Technical Service Bulletin

93 Update OBC software when replacing HV wiring harness for charging socket P31D200

93 24 47 2070110/4 March 22, 2024. Supersedes Technical Service Bulletin Group 93 number 23-17 dated July 26, 2023 for reasons listed below.

Model(s)	Year	VIN Range	Vehicle-Specific Equipment
e-tron quattro	2019	All	OBC Cluster 1
e-tron Sportback quattro	2020

Figure 1. High-voltage wiring harness for charging socket.

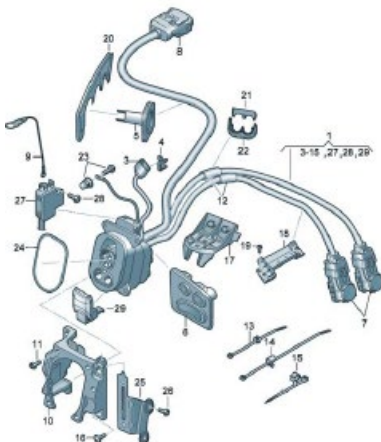
The High Voltage Wiring Harness for the charging socket UX4 or UX5 is replaced as part of any repair work (Figure 1).

The charging socket was modified in production.

From Q2 2020, only the new-generation high-voltage wiring harness for the charging socket is fitted in production vehicles.

It is essential to check the part number of the removed original high-voltage wiring harness and of the new replacement high-voltage wiring harness.

If the high-voltage wiring harness for the charging socket is replaced as listed in Table 1.1, no further measures are necessary and this TSB does not apply.

If the high-voltage wiring harness for the charging socket is replaced as listed in Table 1.2, an SVM code will need to be performed *and a replacement test plan performed*.
